Rep No.B14035
 November 10, 2014

Protective Relay QHA Series Notification of Change to Some Functions of Overcurrent Relays

QHA-OC1 and OC2 Change Details

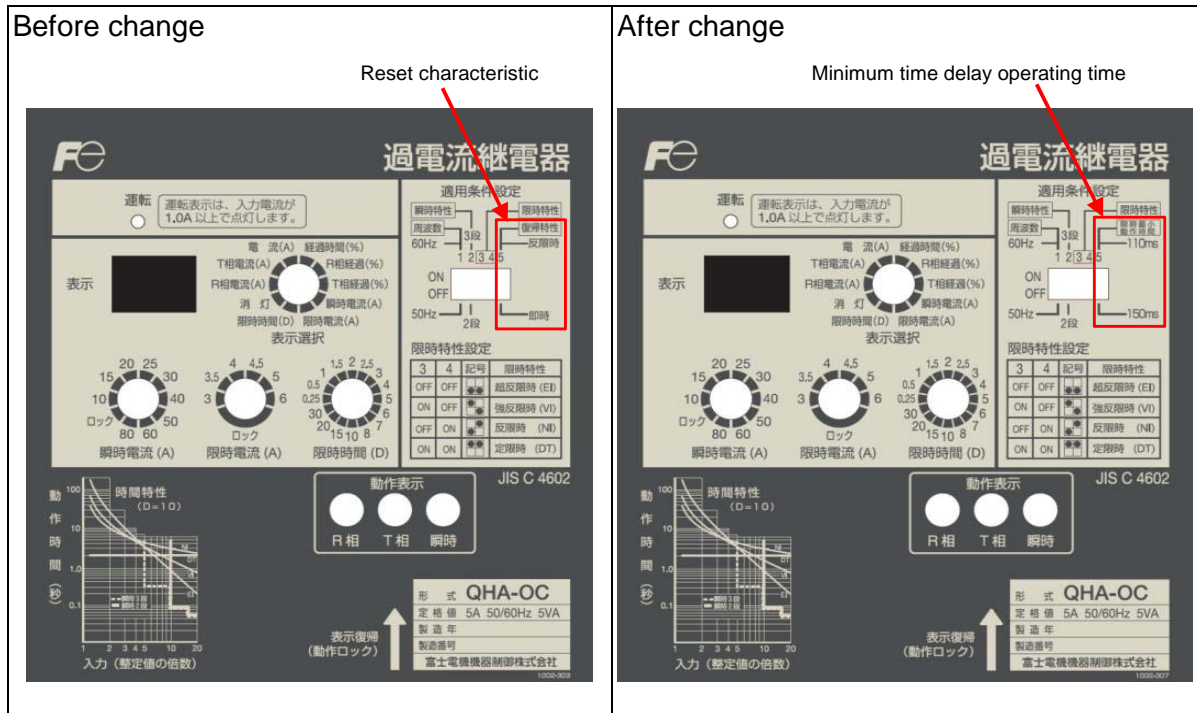
Product names	Overcurrent relay									
Series and series name	QHA Series									
Types	QHA-OC1 QHA-OC2									
Changed parts	Functions of applicable condition setting switch 5									
Details of the change	<p>Functions that can be configured with setting switch 5 will be changed.</p> <p>Products before the change make it possible to select the reset characteristic using setting switch 5 but the minimum time delay operating time cannot be selected.</p> <p>The present change will make it possible to select the minimum time delay operating time, and this makes it impossible to select the reset characteristic.</p>

(1) Change to front face panel indication

(2) Change to characteristic

<table><tr> <th></th> <th>Reset characteristic</th> <th>Minimum time delay operating time</th> </tr><tr> <td>Before change</td> <td>Instantaneous reset/ inverse time delay Selectable</td> <td>150 mS</td> </tr><tr> <td>After change</td> <td>Instantaneous reset</td> <td>110 mS/150 mS Selectable</td> </tr></table>
